Albion Park Quarry Extraction Area Stage 7 Extension

Addendum Noise Assessment

Albion Park Quarry - Stage 7 Extraction Area Removal of Northern Amenity Barrier Noise Impacts

Figure 1 Location of Amenity Barriers

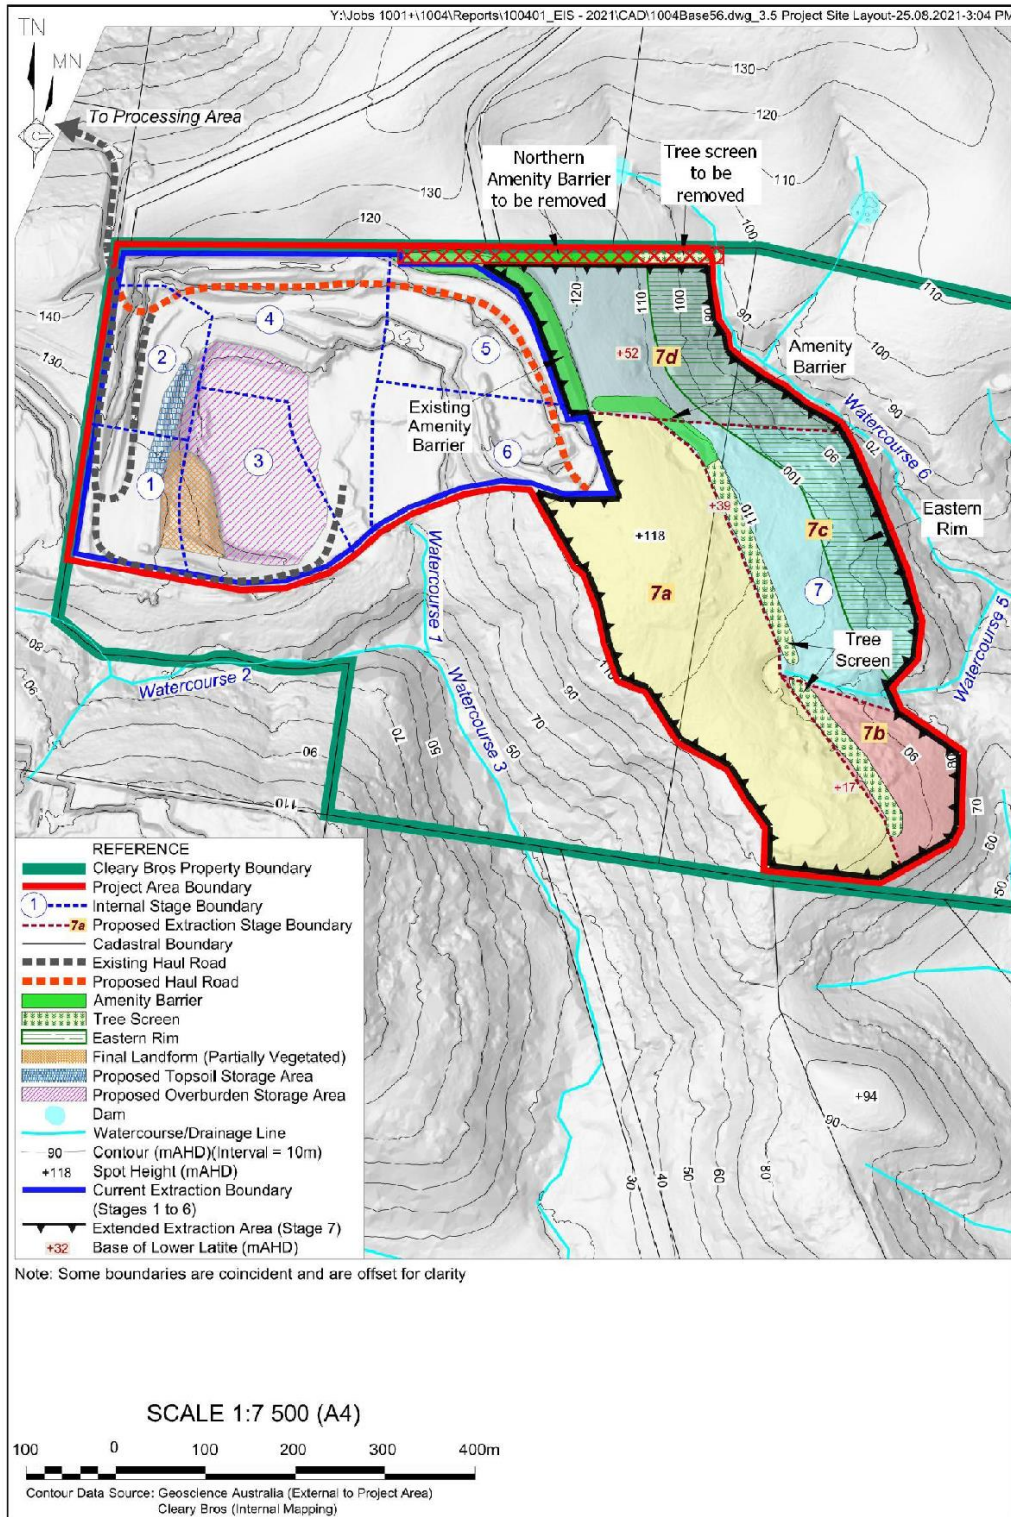
Should the owners of "Figtree Hill" agree, the Northern Amenity Barrier and adjoining tree screen will not be constructed as part of the Project. The temporary amenity barrier and tree screen along the eastern boundary of Stage 7a would still be constructed.

The proposed changes to the barrier layout are shown in **Figure 1**. The location of the Project Area with sensitive receivers and topographic features is shown in **Figure 2**.

The Northern Amenity Barrier and tree screen are located on the northern boundary of the existing Stage 5 area and proposed Stage 7d area. As shown in **Figure 2**, the Northern Amenity Barrier follows the existing ground level which is between approximately 125 m AHD and 110 m AHD. The ridge to the north of the barrier where the "Figtree Hill" residences R1, R2, and R3 are located is at a higher elevation (130-140m AHD). This ridge provides shielding to receivers to the northwest, north and northeast of the Stage 7 area including Greenmeadows Estate, R4, R7 and R8. Receivers to the east and southeast of the Project Area, such as R5, R6, R9, R10, and R11, are not affected by the Northern Amenity Barrier.

Figure 2 Sensitive Receivers and Local Topography (to be updated by RW Corkery)

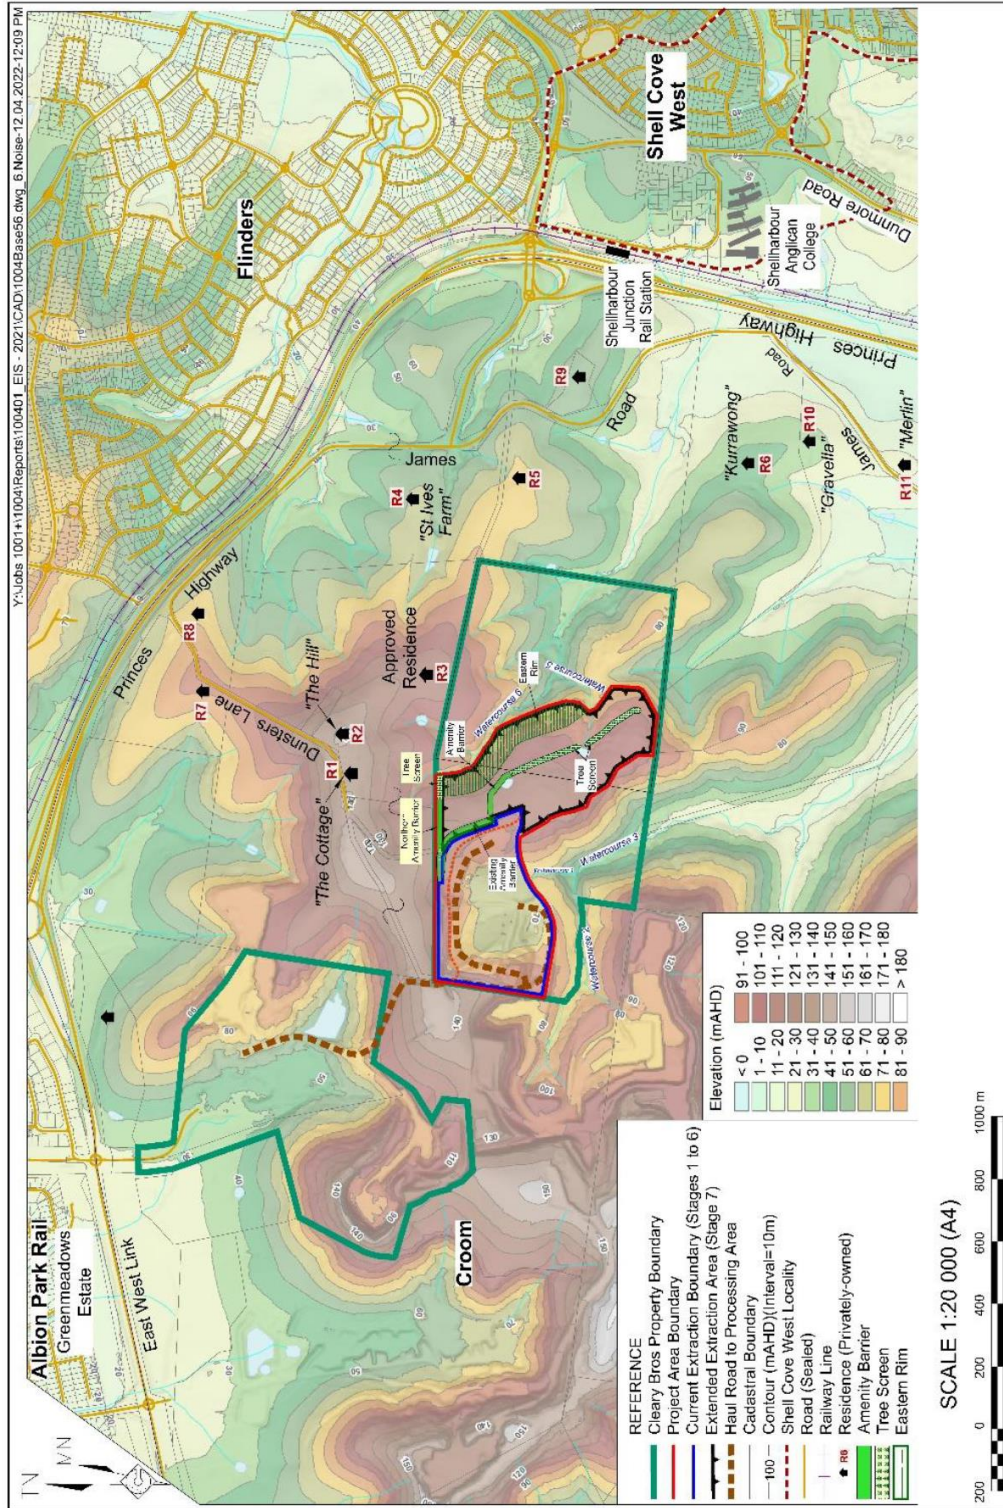
- The barrier is below the line of sight to the surface activities at "Figtree Hill" (R1 and R2);
- Receivers further north and northeast are shielded by the higher elevation of "Figtree Hill" and the adjoining east/west ridgeline (Greenmeadows, R7, R8); and
- Receivers to the east are not shielded by the Northern Amenity Barrier (R3-R6, R9-R11, Shell Cove West).

Removal of the Northern Amenity Barrier is not predicted to change noise levels predicted at the sensitive receivers assessed in the *Stage 7 Extension Noise and Blasting Assessment*. Noise model results indicated the following:

- The maximum noise levels predicted in the Noise and Blasting Assessment dated February 2022 are predicted to be consistent (no change in predicted noise levels) at the Figtree Hill residences in the absence of the Northern Amenity Bund and adjoining Tree Screen, and
- There will be no change in impact for any other sensitive receiver in the absence of the Northern Amenity Bund and adjoining Tree Screen.
